FOIA/PA NO:   2013-0240

**From:** Wagner, Katie  
**Sent:** Tuesday, May 15, 2012 7:56 PM  
**To:** Barto, Andrew; Sullivan, Randy; Schrader, Eric; Jones, Steve; Mitman, Jeffrey; Bowman, Eric; Witt, Kevin; Tegeler, Bret; Powell, Eric  
**Cc:** Gibson, Kathy; Scott, Michael; Poole, Brooke; Lewis, Robert; Ruland, William; Glitter, Joseph; McGinty, Tim; Ader, Charles; Bergman, Thomas; Skeen, David; Evans, Michele; Clifford, James; Lee, Richard; Coyne, Kevin; Hogan, Rosemary; Santiago, Patricia; Wood, Kent; Hansell, Samuel; Ennis, Rick; Esmaili, Hossein; Helton, Donald; Murphy, Andrew; Nosek, Andrew; Pires, Jose  
**Subject:** RE: ACTION: Spent Fuel Pool Scoping Study (SFPSS) Working Draft for Working Group Review by EOB on Tue., May 22nd

I am providing for your information two documents: (1) A list of the division director level comments that you provided in response to my request on 3/22/13 and our responses, and (2) a copy of the version of the report that was sent today to ACRS.

Sensitivity of  $k_{eff}$  to Uniform Boraflex Degradation for Various Fresh Fuel Enrichments.

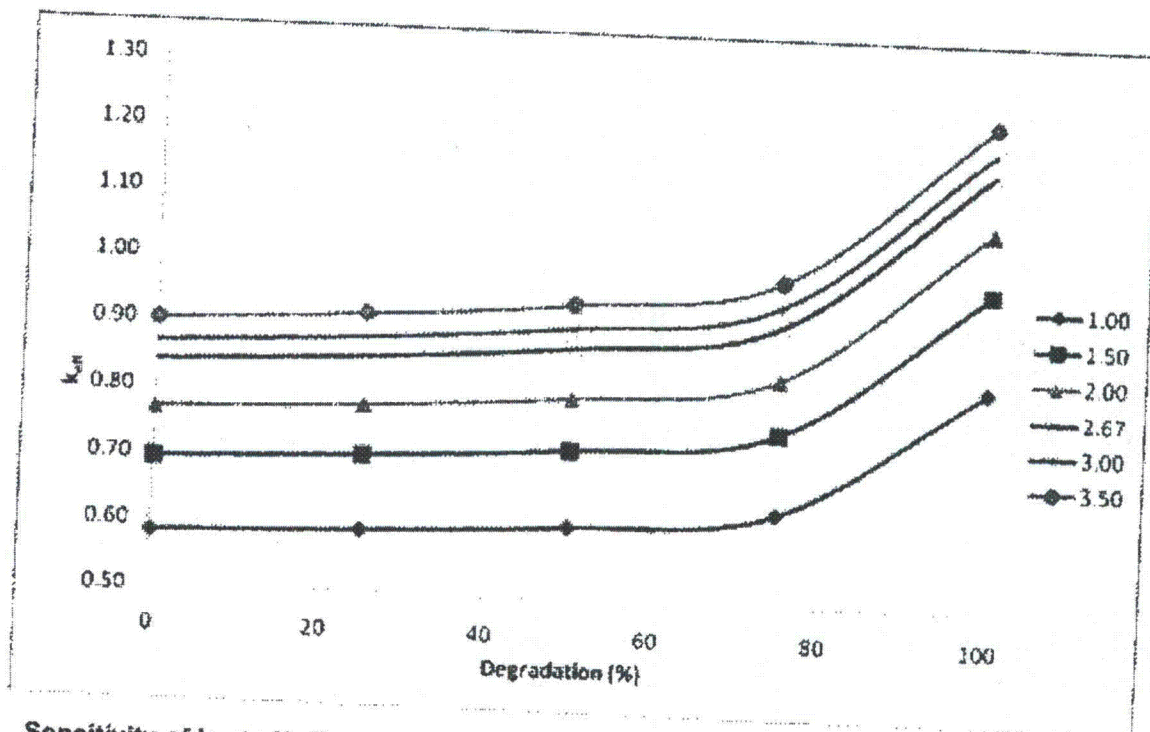
The purple curve would likely be of most interest since this corresponds to the reactivity equivalent of spent fuel at peak reactivity. Of course, this is for full density water. If you still want, I can do a criticality search iterating over moderator density at 100% absorber degradation to find the optimum moderation. Let me know.

I'm not sure how helpful this particular case is considering we don't know their pool design and management scheme.
